# TECHNICAL SERVICE BULLETIN

# Triumph

EXHAUST MOUNTING RUBBERS

TR7

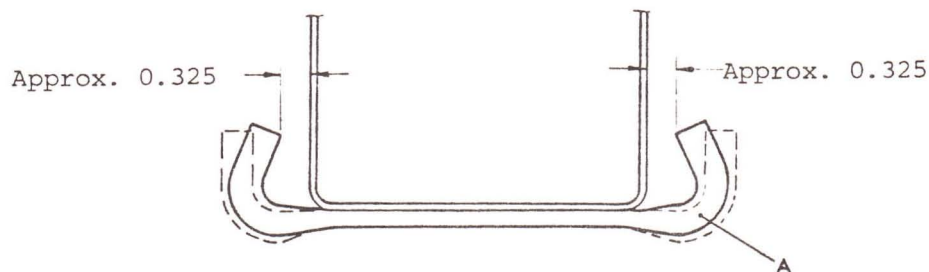
Complaints have been received of the rubber support rings on the rear exhaust silencer becoming detached from the supporting hooks. The left hand rear chassis side member welded bracket has now been modified as shown in the diagram marked 'A'.

The modification was introduced in production at VIN #ACW 32113. In the event that this complaint is encountered, it will be necessary to re-set the supporting hooks as illustrated.
